Device Position Description	WAI-VUD-A0025	
Tower	67-3	
Contract number	S2G-3	
Tower Type	0	
Body - size	0	
Body Extn - size	0	
Legs - size	+/-0, +1, +/-0	
Earth Wire	YES	
Paint Type	0	
Tower Area m²	104	
MAD Tower Area m²	6	
Spot Blast m²		
Rust m²	7	6%
Sweep m²	76	73%

Wailoa- Vuda

LANDOWNER DETAILS		INSPECTION TEAM LUMEN		Date	GPS COORDINATES (WGS84)			WAI-VUD A Paint Towers 19/20								
LandOwner	Refer To Efl	Inspector-Tower	Karl Formo	7/07/2023	LATITUDE	17°42'38.52"S		DRG. SIZE	SCALE	FOLDER						
				A3				N/A	CAP18365							
				TowerAccess				Second Turn Left After Fulton College Off Sabeto Road, Sabeto, Nadi District	Inspector-Ground	Karl Formo	LONGITUDE	177°31'4.80"E	WID	MR57-2021	SHEET	REVISION
															1	2
ContactName	Refer To Efl	Draft Report	R. Glover	24/04/2023			Work Scope Assessment Report - Jun-2023									
ContactPhone	Refer To Efl	Report Review									WAI-VUD-A0025

VUDA - WALOIA LINE
TOWER 67-3(25) OUTLINE

Structure looking towards CD Face

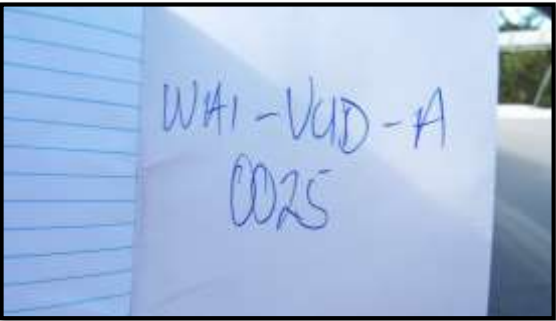
track access maintenance required prior to entry
no cpi - fiji
minor vegetation management needed around base of structure.
cte painted 1m up each leg
light zcp through out structure
dross throughout structure on steel
there are two river fords on the way to the structure, exercise caution during wet season
bird excrement on members throughout structure
lsd - missing
minor bend on k-brace, on d-leg
cd face.

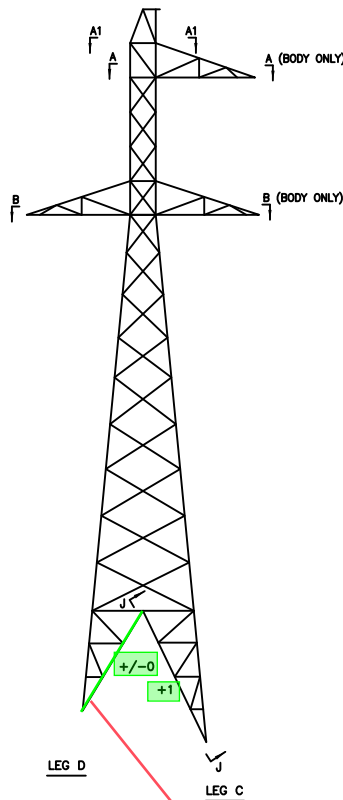
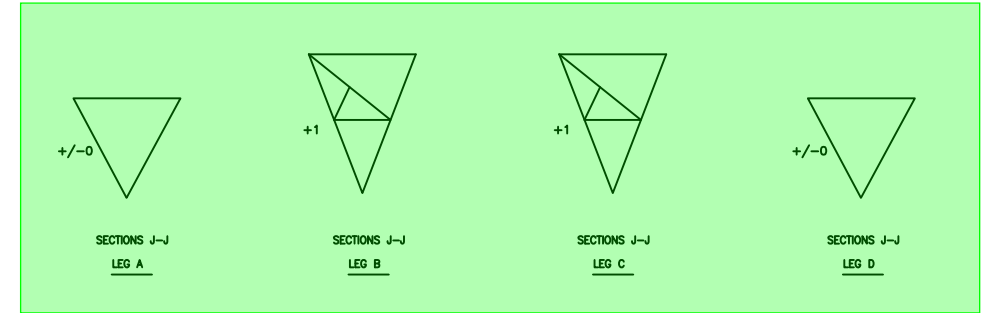
ADD IN EXTRA STEEL

ADD IN EXTRA STEEL

S2G309 MINOR BEND

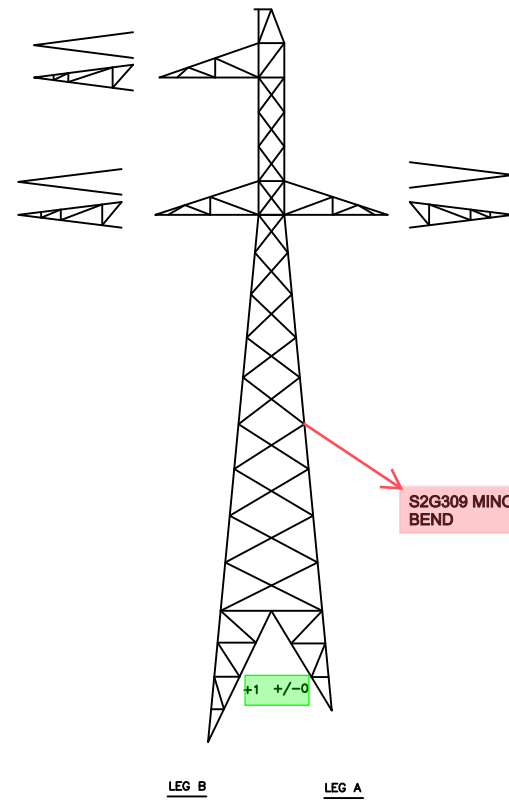
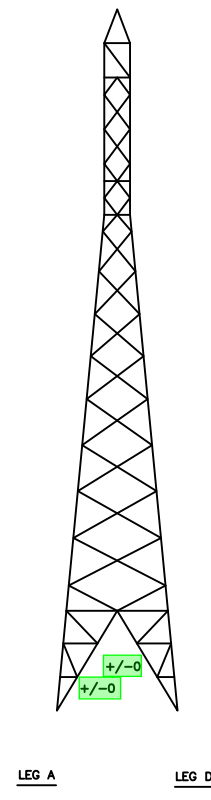
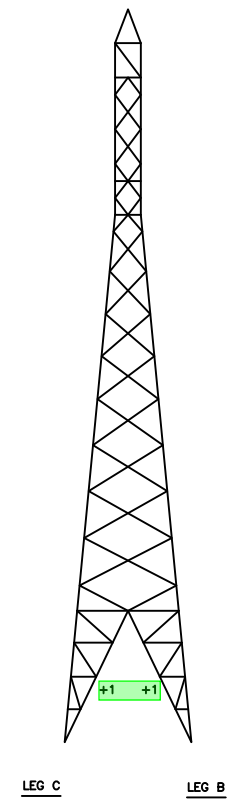
#1 K BRACE PAINT
MINOR BEND ON K BRACE
